28 October 2015

SUBJECT: Development Application Emanuel Synagogue – Ocean Street, Woollahra
File No; DA 307/2015/1 – Development Application Assessment Report

CONDITION A)

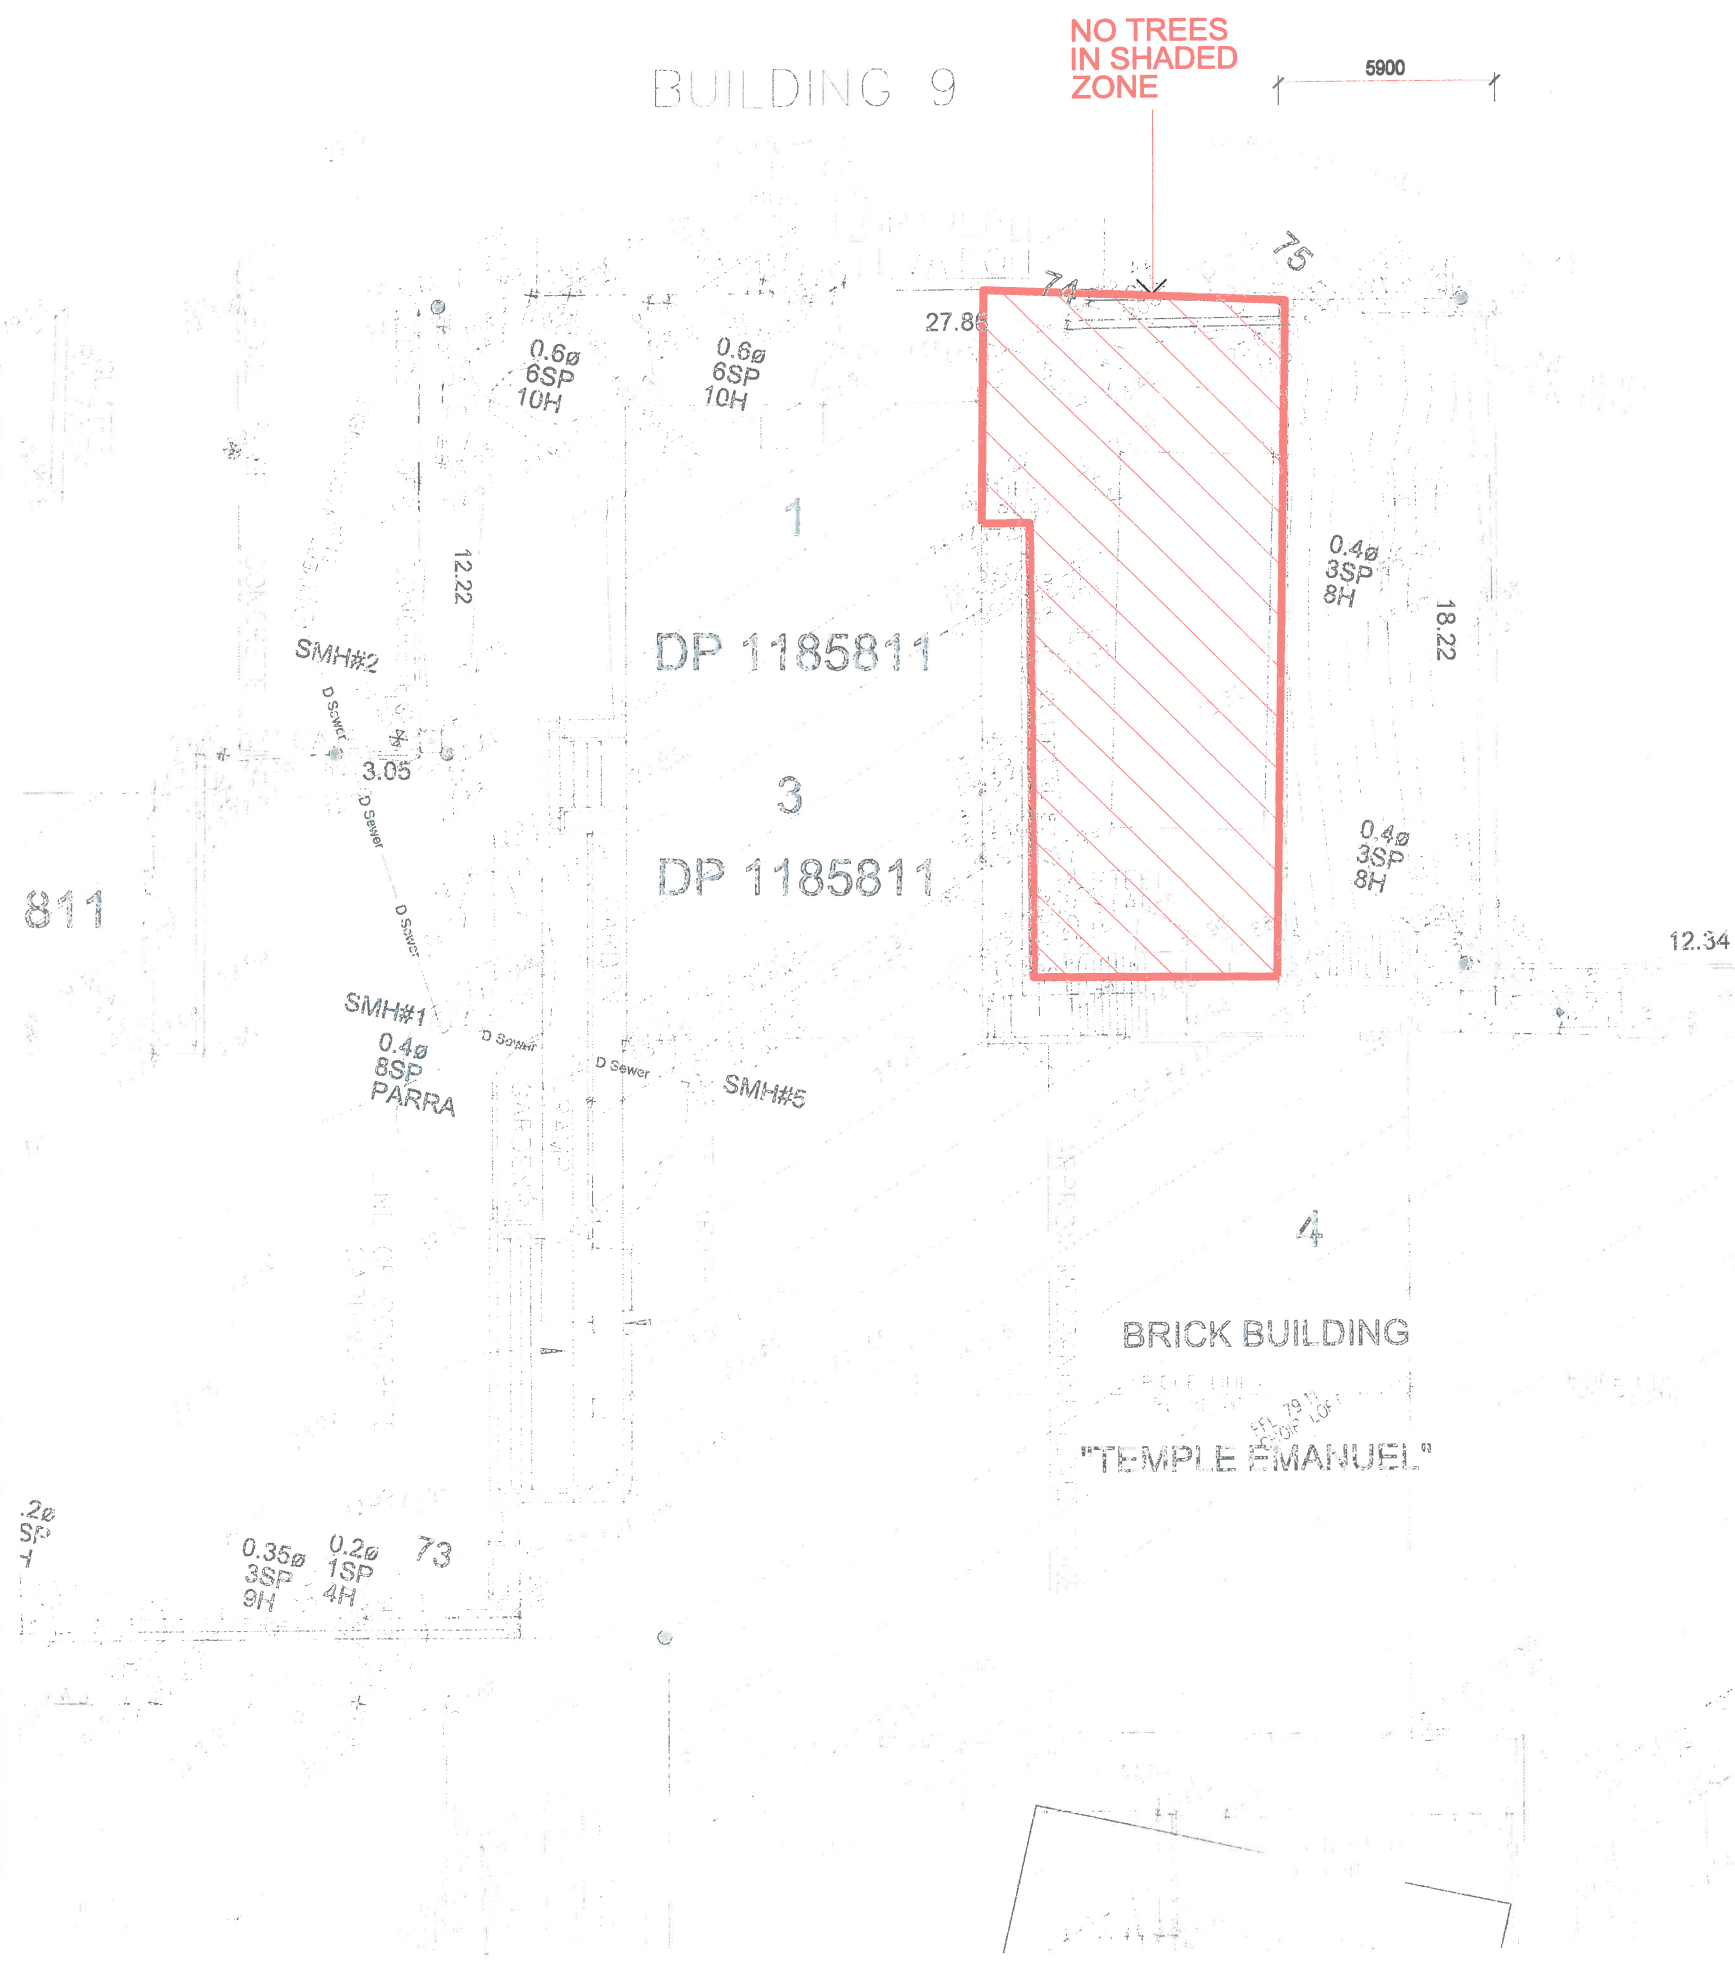
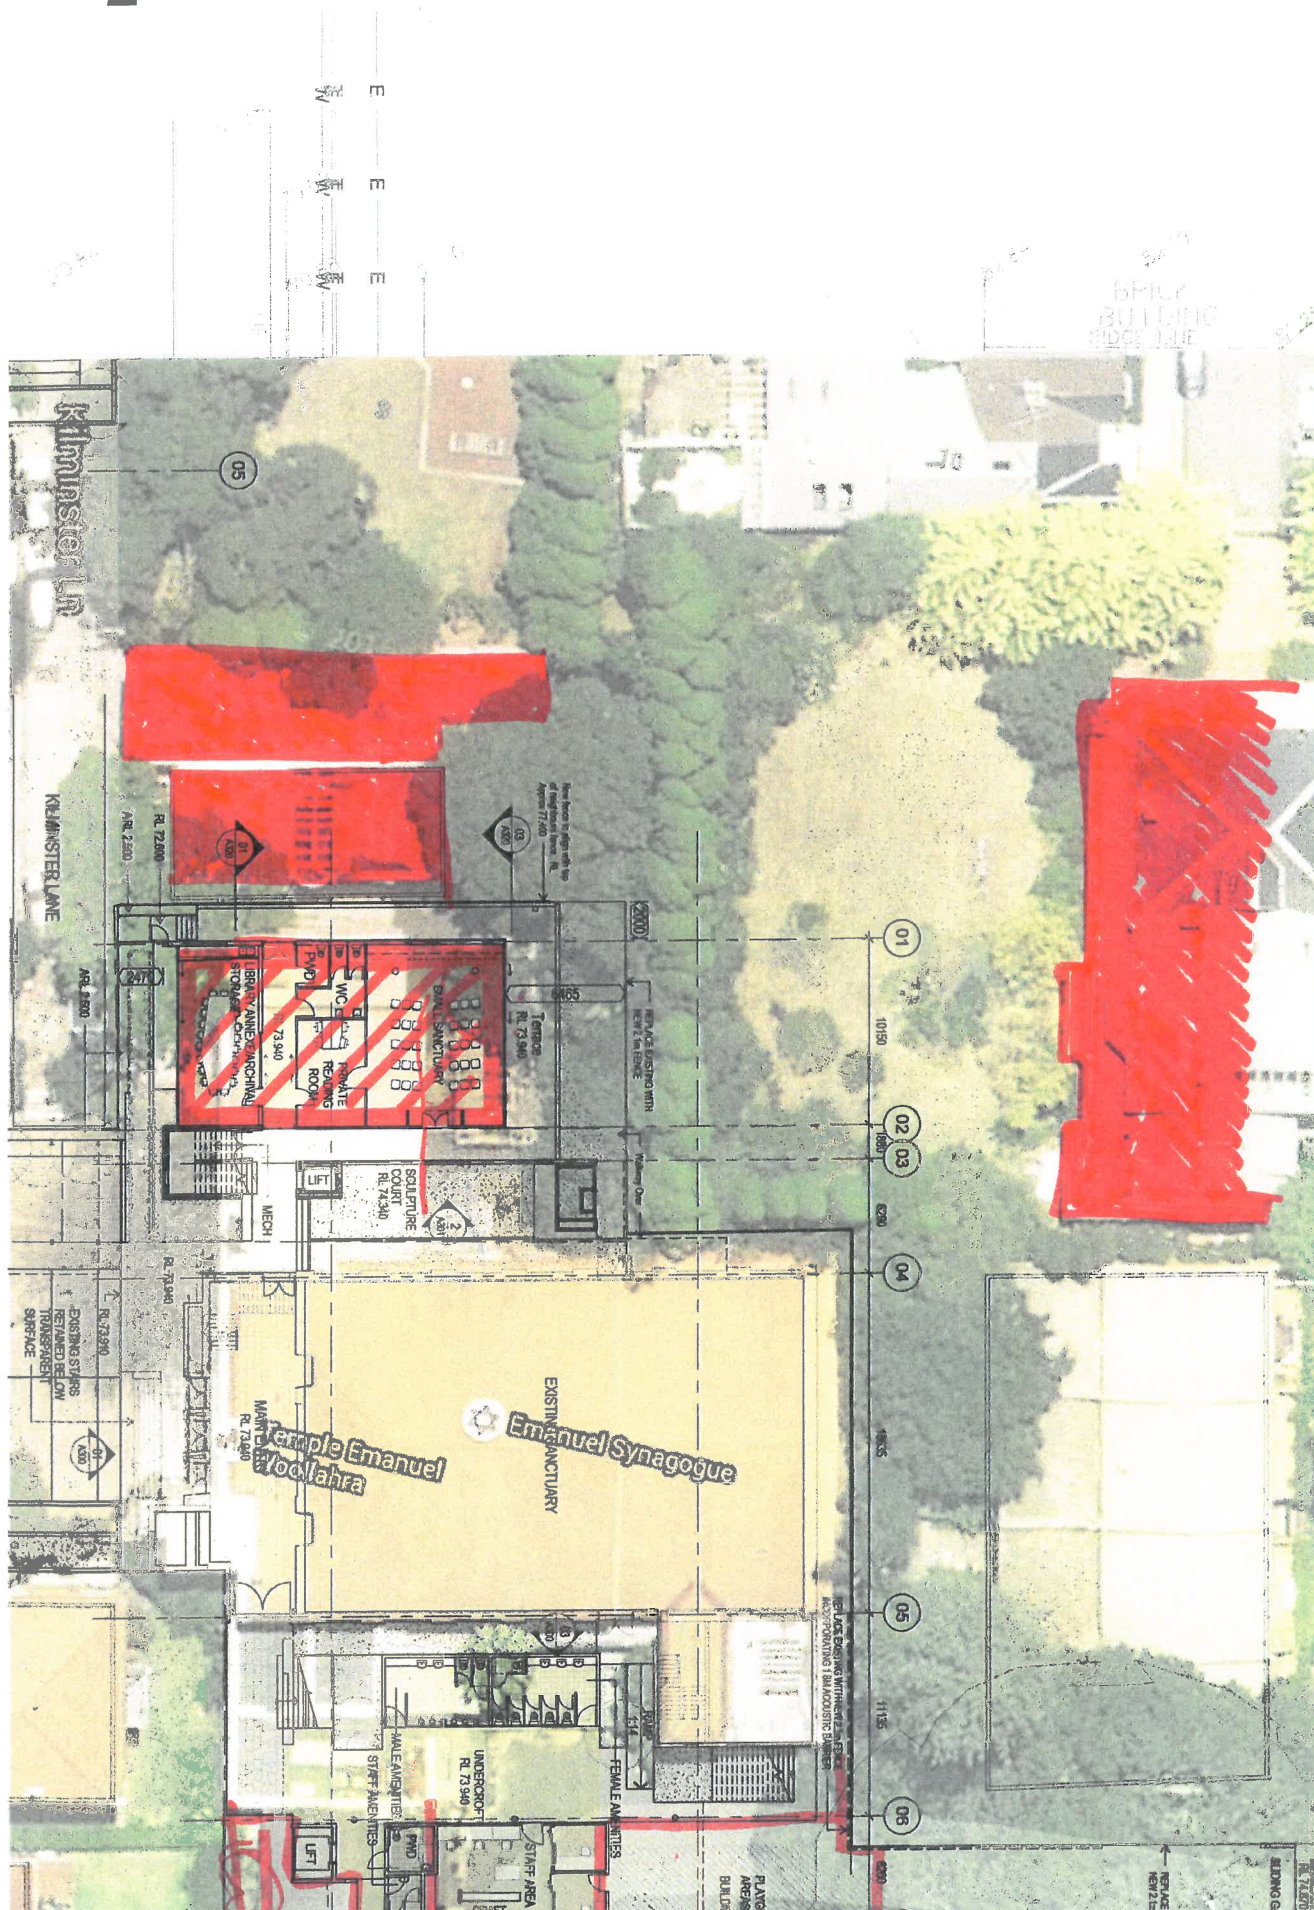
Because of the landscape screen on the western boundary, the visual impact of the new mid-sized sanctuary will not be significant. That said, we are prepared to find ways to lower the height of the existing sanctuary wherever possible and appropriate without making the building unworkable. The lowering in height of the roof should respect the following:

- Don't exceed the height of the existing brick parapet of the existing heritage listed sanctuary at the northern end
- Lower the roof at the southern end to 80.85 in accordance with the Planning Officer's recommendation with consideration to permit potential raking of the roof consistent with the mid-winter solar plane.

- a) *Exclusive of the two skylights, the height of the Sanctuary building to the South of the Temple Emanuel is to be lowered to ~~a minimum of 1.5m~~ a maximum of RL 80.85 at its southern end and a maximum ~~RL 82.35~~ RL 83.74 to match the existing heritage brick parapet/front façade of the existing Sanctuary at the Northern end.*

Refer to DIAGRAM 1 attached.

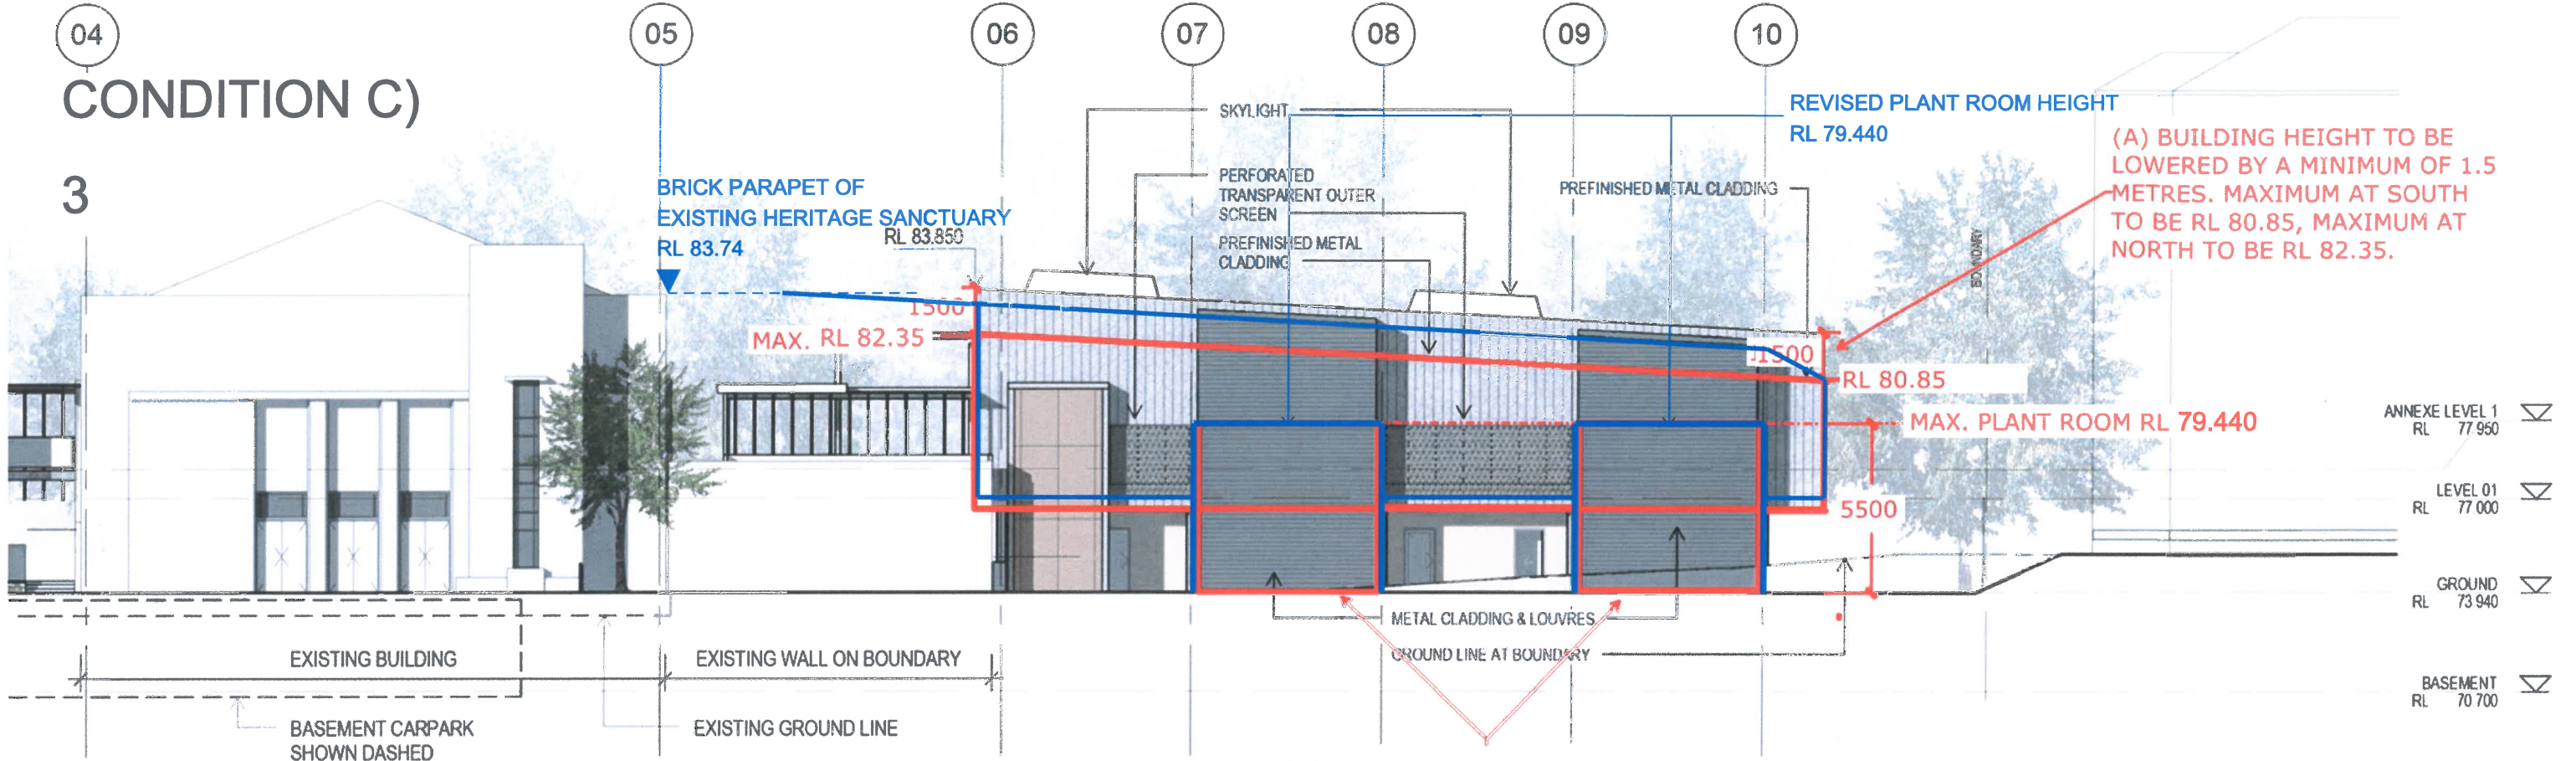
The trees shown on the landscape architect's drawings are inaccurately positioned and the proposed sanctuary and learning space does not involve the removal of any trees. Further, the setback from the building on Waimea Ave is approximately 20 metres and there is no impact from the proposed siting of the proposed building in the north-eastern corner of the site on any neighbours

- b) *~~The setback off the Sanctuary building at the north of the Temple Emanuel from the eastern boundary with 14 Waimea Avenue is to be increased to a minimum of 9.0m at both levels.~~*

Refer to DIAGRAM 2 attached.

CONDITION C)

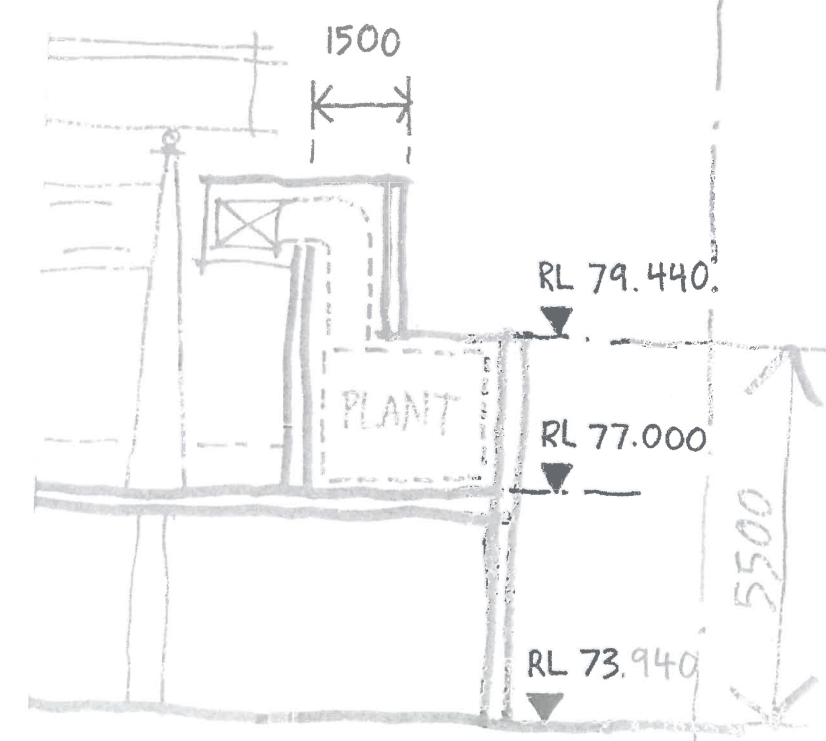
The Officer's recommended plant room height is acceptable however we will need to build out the western wall of the sanctuary/art gallery by 1500mm to accommodate air-conditioning ductwork. We also note the anomaly on the condition in that 5500 in height above the ground floor level is RL 79.44 not 78.40.

- c) *The plant rooms to the west of the Sanctuary building to the south of the Temple Emanuel are to be limited to a maximum height of ~~5.5m (RL 78.4)~~ RL 79.44 to permit mechanical ductwork in the lowered roof of the sanctuary.*

Refer to DIAGRAM 3 attached

(C) PLANT ROOMS TO A BE LIMITED TO A MAXIMUM HEIGHT OF 5.5 METRES AT RL 79.440
